Project	IEEE 802.16 Broadband Wireless Access Working Group < http://ieee802.org/16 >
Title	Amendment to RSA Security Primitives in 14.2.2.2
Date Submitted	2007-03-0813
Source(s)	Jung-Mo Moon, JeeHyeon Na, Mi-Young Yun, and Sangho Lee jhna@etri.re.kr ETRI 161 Gajeong-dong, Yuseong-gu Daejeon 305-700 Korea
Re:	Contribution on comments to IEEE 802.16g/D8
Abstract	Re-definition of RSA primitives in section 14.2.2.2
Purpose	Adoption
Notice	This document has been prepared to assist IEEE 802.16. It is offered as a basis for discussion and is not binding on the contributing individual(s) or organization(s). The material in this document is subject to change in form and content after further study. The contributor(s) reserve(s) the right to add, amend or withdraw material contained herein.
Release	The contributor grants a free, irrevocable license to the IEEE to incorporate text contained in this contribution, and any modifications thereof, in the creation of an IEEE Standards publication; to copyright in the IEEE's name any IEEE Standards publication even though it may include portions of this contribution; and at the IEEE's sole discretion to permit others to reproduce in whole or in par

Figure 474 – RSA based Authentication Procedure

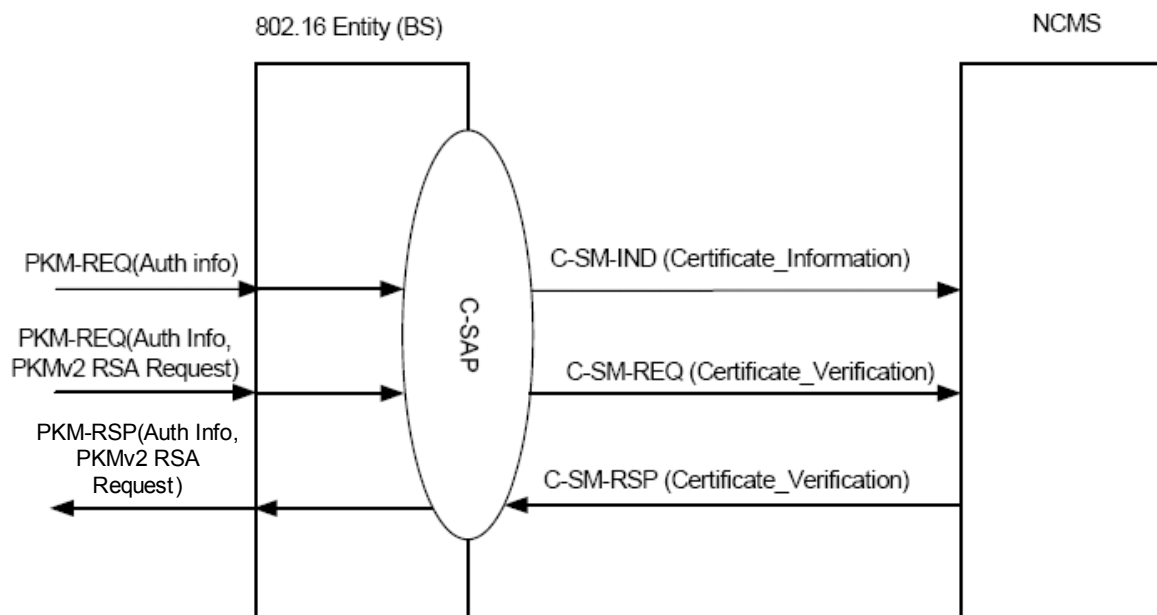
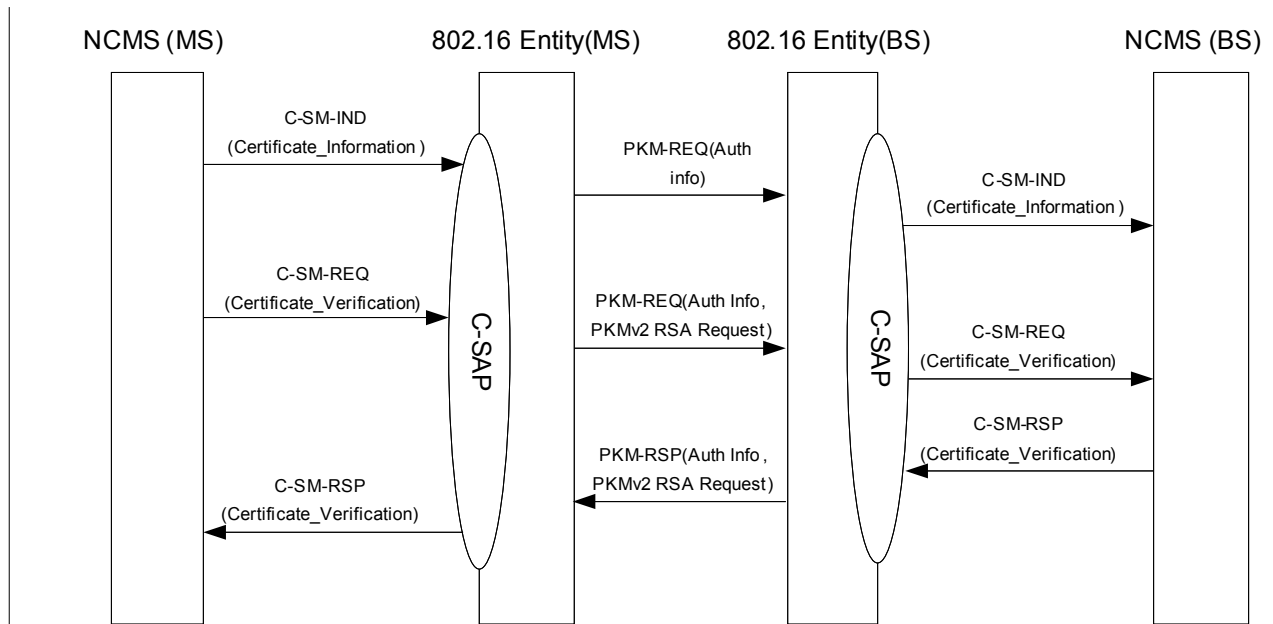
1. Modification of figure 474 which illustrate security primitives on the SS side.
2. Modification of each subsection to clarify and describes on each side (SS and BS side)

Figure 474 shows a RSA-based authentication procedure between an 802.16 entity a BS and ~~the~~ an NCMS on the MS side and the BS side entity as follows:
